Subject: Oconee Nuclear Station  
Docket Nos. 50-269, -270, -287  
Response to Request for Additional Information on  
the Oconee Emergency Power System

REQUEST FOR ADDITIONAL INFORMATION  
OCONEE EMERGENCY ELECTRICAL POWER  
DISTRIBUTION SYSTEM

— lb-rms

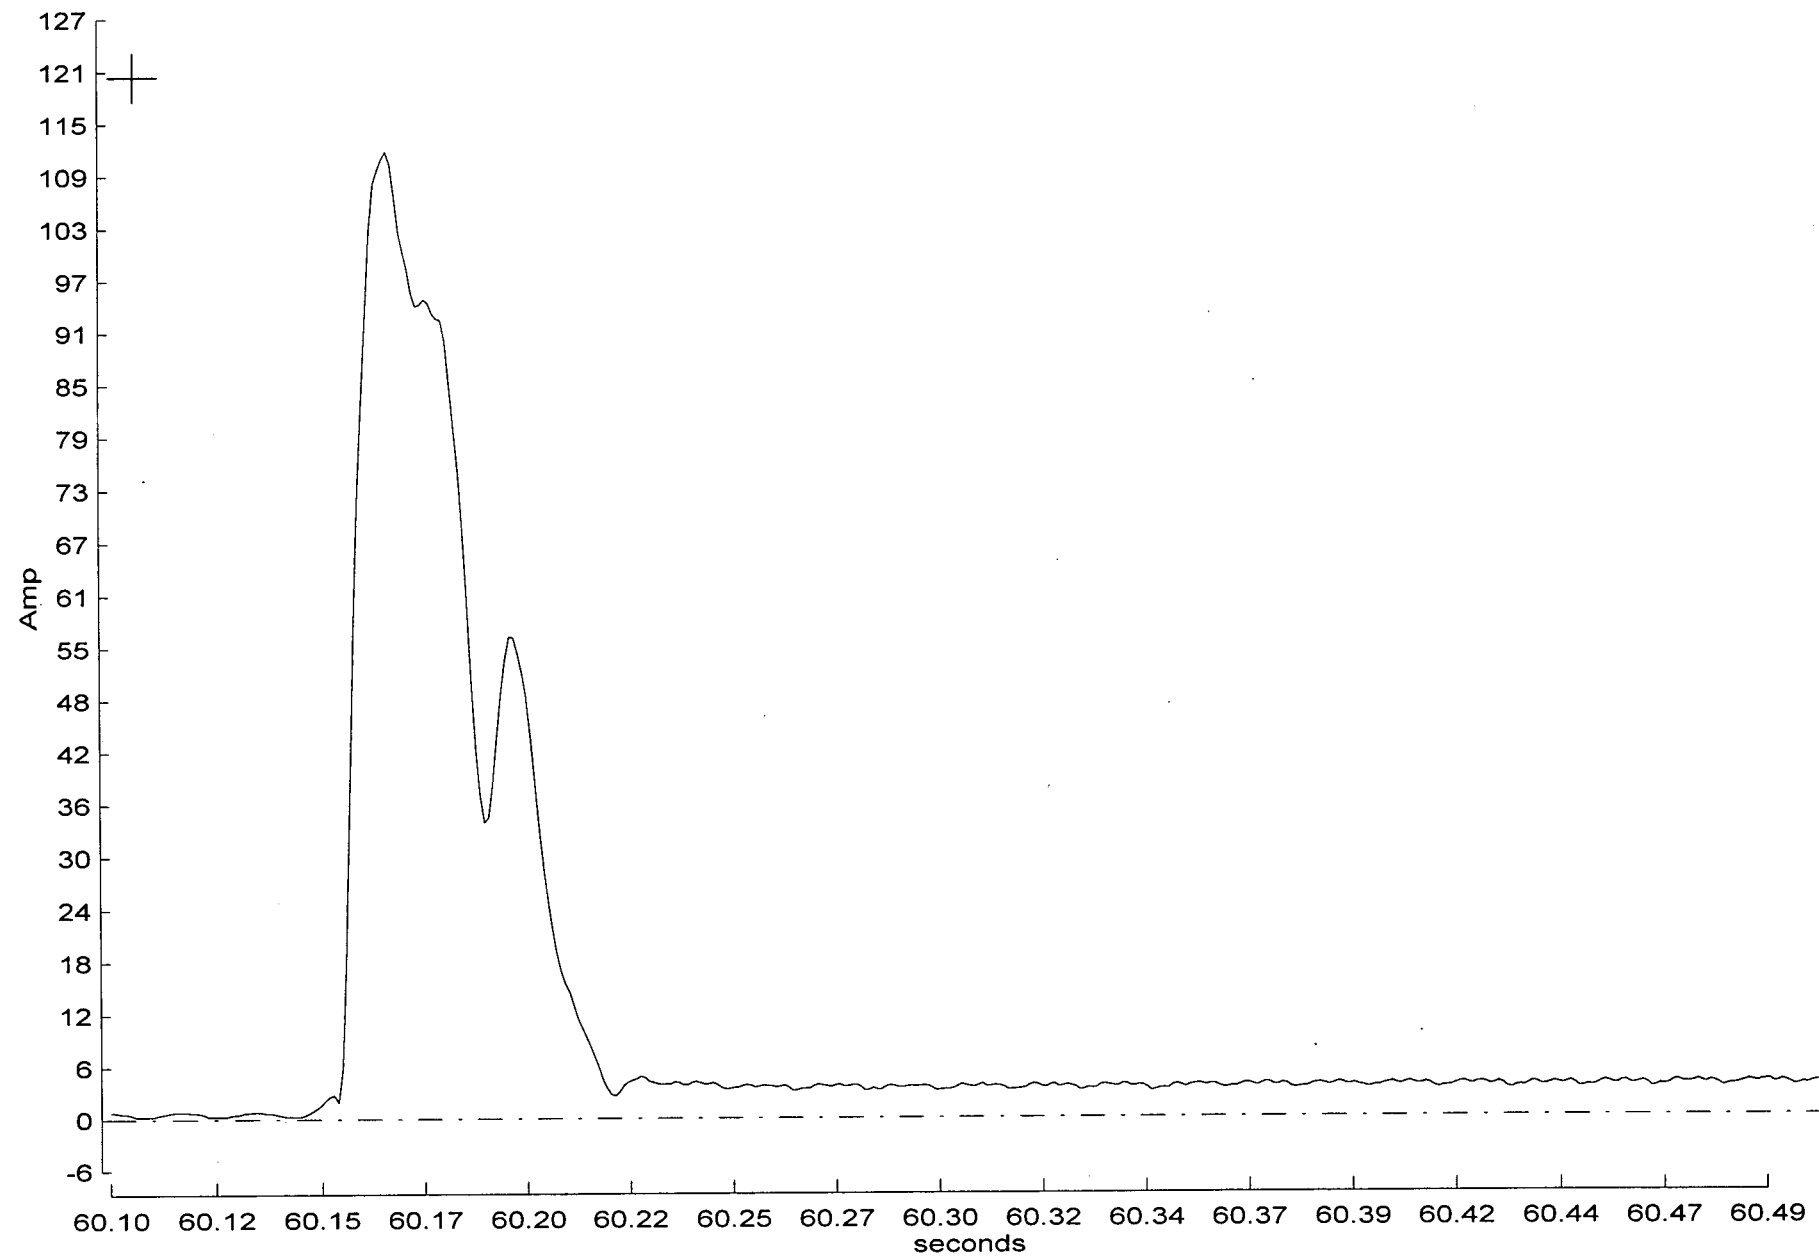
7. Section 5.2.4 of the report states that MOV 3LP-17, which is a gate valve, briefly stalled while starting following contactor pickup during Tests 4, 5, and 6. The stall times were 1.0, 1.0, and 0.4 seconds, respectively, for the three tests. The report indicates that the valve recovered in each case and completed its stroke to its proper ES position; and following inrush, valve stroke was normal and normal hammer-blow and unwedging was observed. We note that in all the LOCA tests where the MOVs are actuated, this particular valve's motor contactor picks up at a voltage value that is quite often one of the largest values seen on the group of valves that are monitored. On that basis, not considering any other variables, it would be expected that this valve would be the least likely to stall.

- d. Please provide plots of the valve motor's thermal capability and overload protection, overlaid on the starting inrush current figures shown for this valve during the tests.

monitored phases was analyzed for inclusion in the report since all valve stroke events could be identified regardless of which phase was analyzed. A more detailed review of the data for all three monitored phases indicates that the primary reason 3LP-17 appeared to stall was that the 'c' phase starter contact chattered while the 'a' and 'b' phase contacts maintained a stable energized state. Therefore, the 'a' and 'b' phases (one of which was included in the report) indicated stall conditions until the 'c' phase contact maintained a stable energized state. Once all three phases were energized, 3LP-17 stroked as expected. In retrospect, 3LP-17 did not actually stall as originally thought. Attachment 6 contains the plots of the current data for 3LP-17 which indicate the chattering of the 'c' phase contact.

Copies of the requested plots are contained in Attachments 2 through 6.
